Analysis of Surface Water Temperatures, Headquarters Landfill

TECHNICAL MEMORANDUM

TO: Cal Palmer
FROM: Eric Tuppan
RE: Analysis of Surface Water Temperature-Headquarters Site

DATE: March 5, 2013
PROJECT: TE-001-001

Attachment: Plot of Historical Temperatures in Southern Tributary Sucker Creek

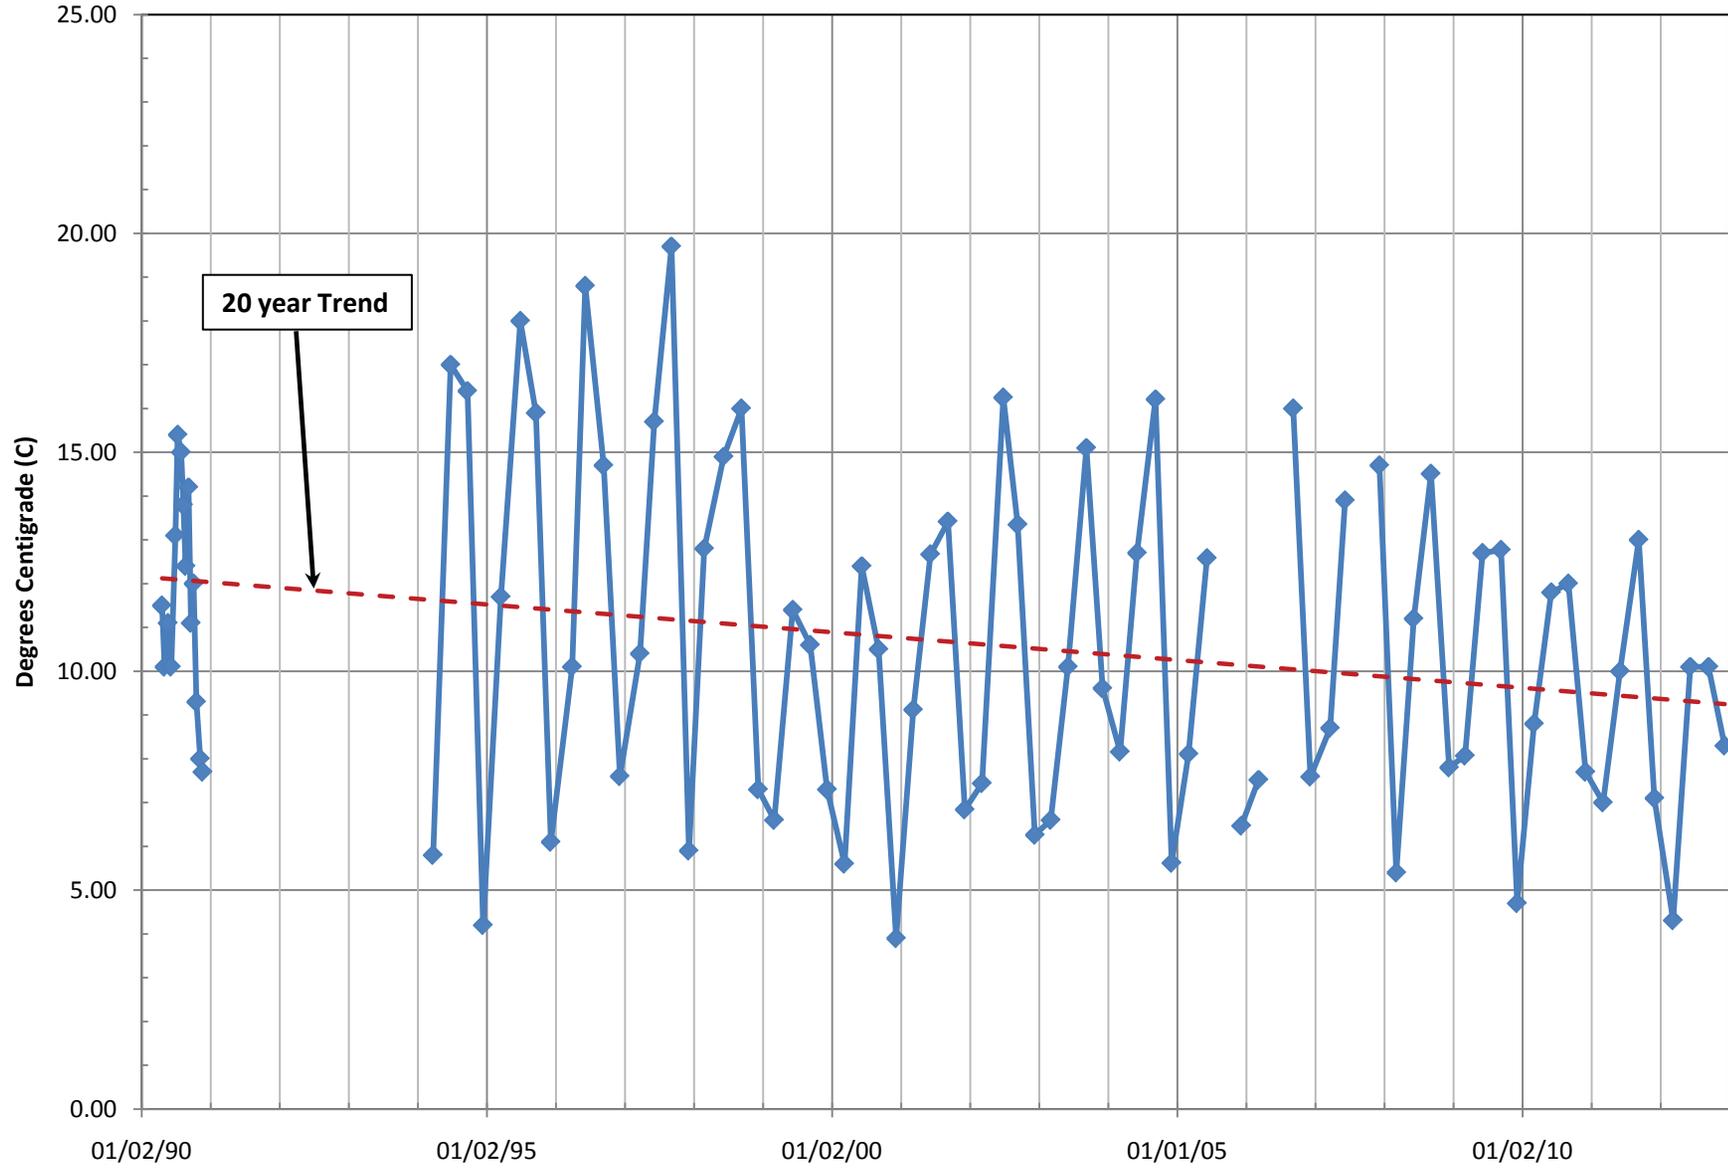
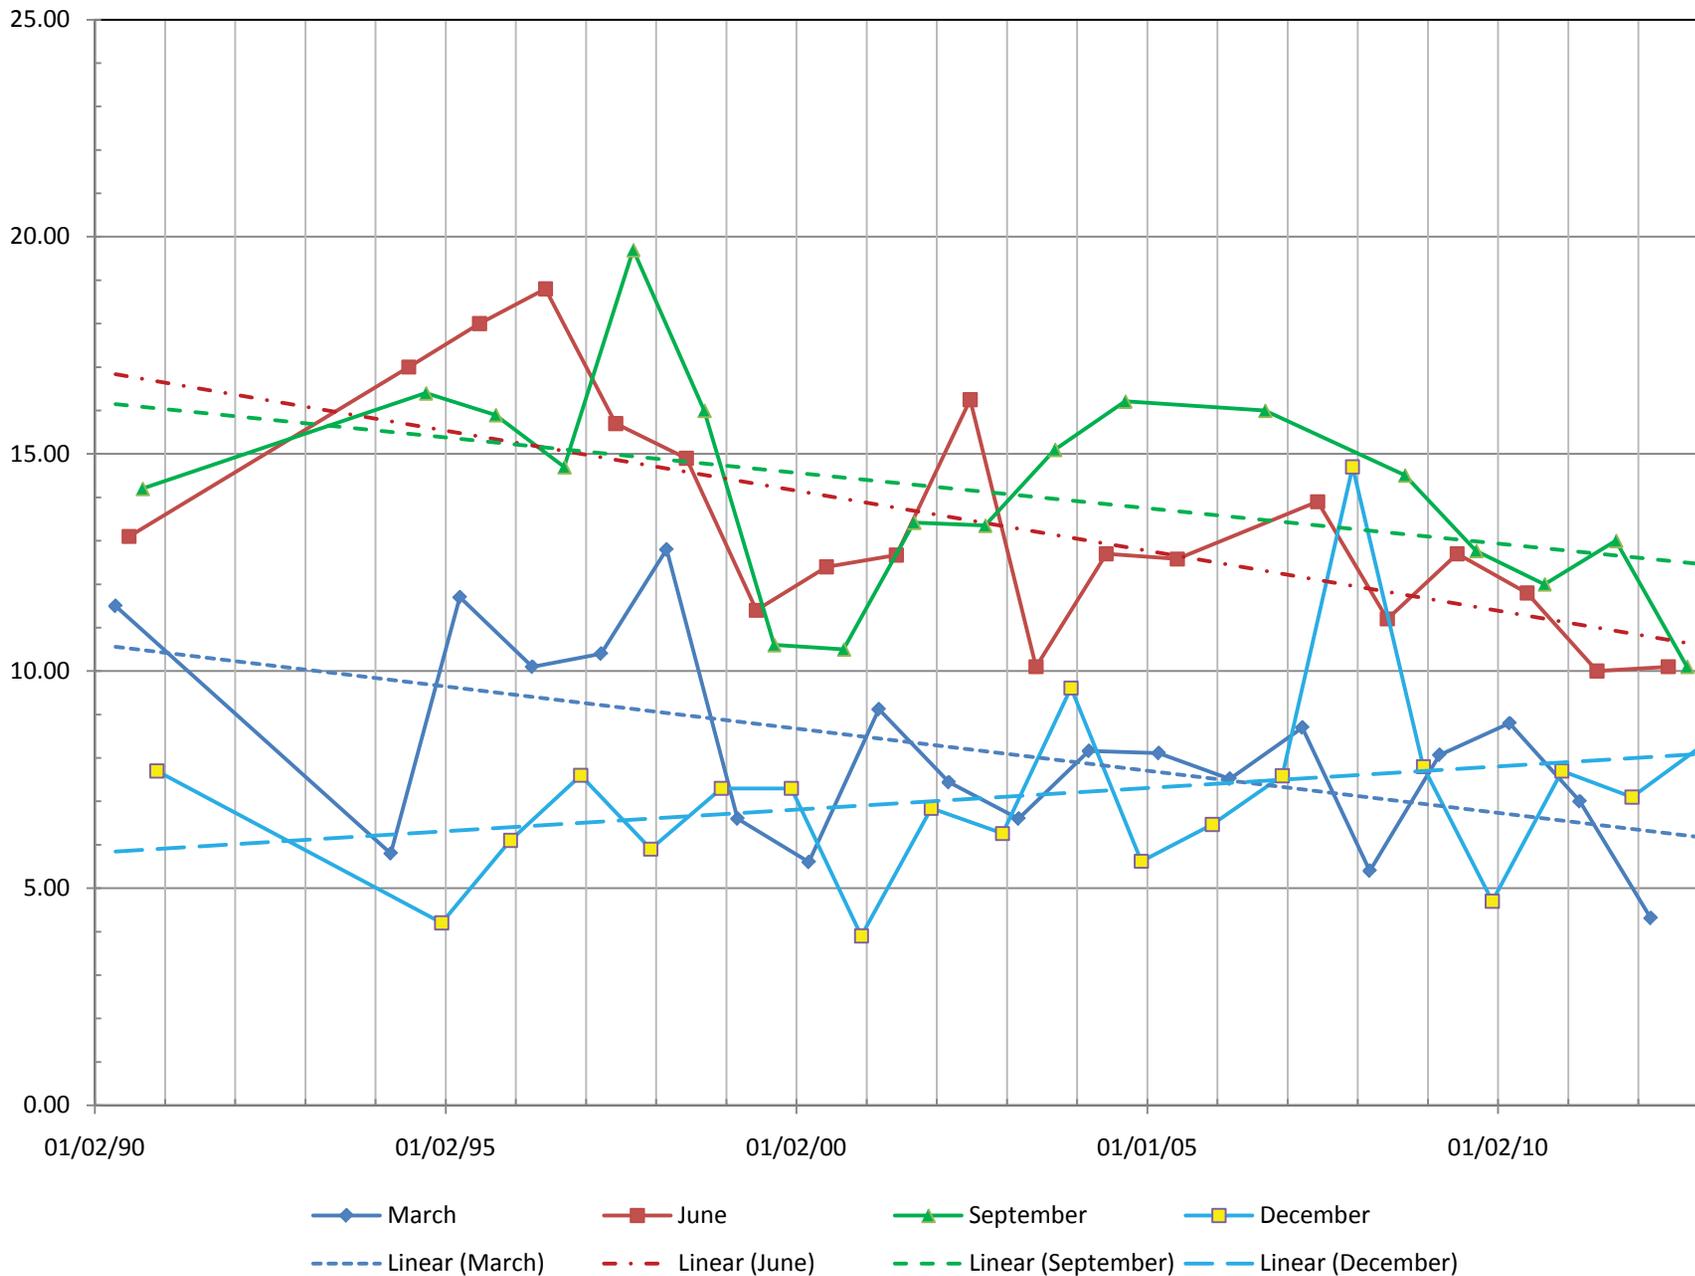
In its comments on the draft Environmental Impact Statement (EIS), the Department of Ecology (Ecology) states that "*Given that leachate or stormwater runoff will be produced under either landfilling scenario, and that reduced groundwater recharge will reduce base flow in the Southern Tributary and Sucker Creek, it seems likely (emphasis added) that stream temperatures will increase as a result of either alternative. However, the first sentence of the 3rd paragraph on page 13 states, 'Stream temperatures and stream shading would not change as a result of the Proposed Action.' Ecology notes higher landfilling rates under the proposed alternative (tons received per year) would likely lead to earlier increases in stream temperatures.*"

Ecology's comment that higher landfilling rates (i.e., higher waste flows) would likely lead to earlier increases in stream temperatures is based on two concepts that are incorrect in the assessment of this proposal. The first is that temperatures would increase by the very fact of the landfill's presence; this is clearly not the case as previously discussed. The second is that faster development under the Proposal compared to No-Action would

Moreover, temperatures monitored in the Southern Tributary since operations began in 1993 show that the trend of stream temperatures has declined over the past 20 years (see attached figures). This can be attributed to the mitigation efforts embodied in the upper diversion channel and increased stream side shading implemented at the time of landfill construction
